# UNITED STATES PATENT AND TRADEMARK OFFICE

10/591,026

| <b>Office Action Summary</b> | <b>Application No.</b><br>10/591,026 | <b>Applicant(s)</b><br>KANIE, NAOKI |  |

**DETAILED ACTION**

Yamamoto Figure 8

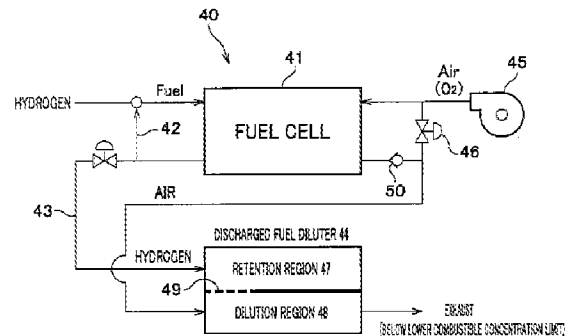
Claim 1 and 10: Yamamoto teaches a fuel cell system comprising a means for diluting (44) hydrogen gas that has been purged from the fuel line via a purge pipe and valve (43). The system also comprises a change means (46) that increases the supplied quantity of oxidizing gas when there is an over abundance of hydrogen in the system so that the concentration of hydrogen being exhausted from the system is constant [Paragraph 78-80]. Yamamoto teaches discharging based on time intervals [Paragraph 64] and fails to teach a detection of abnormality to induce a purge.

Manery teaches a fuel purge valve (70) and a voltage sensor (output quantity) (S4) wherein when the voltage sensor drops below a threshold, a purge is induced [Paragraph 50]. The purge valve control is taught to be element CS4. It would have been obvious to incorporate the teachings of Manery with Yamamoto because Manery teaches an improved controller system for fuel cell systems that includes a battery [Paragraph 7]. One of ordinary skill in the art would search for such a control since Yamamoto is silent as to the various controllers that operate the system. The specific motivation for the purge valve sensor is that Manery teaches a sensed purge will

Claim 7: Yamamoto teaches a valve as the means for discharging [Figure 8].

Claim 8: Yamamoto teaches a valve (43) for purging, a dilution device (44), oxidizing gas supply (45) and means that can increase to keep hydrogen concentration constant (46, 50). Yamamoto fails to teach the specifics of the system including various sensors.
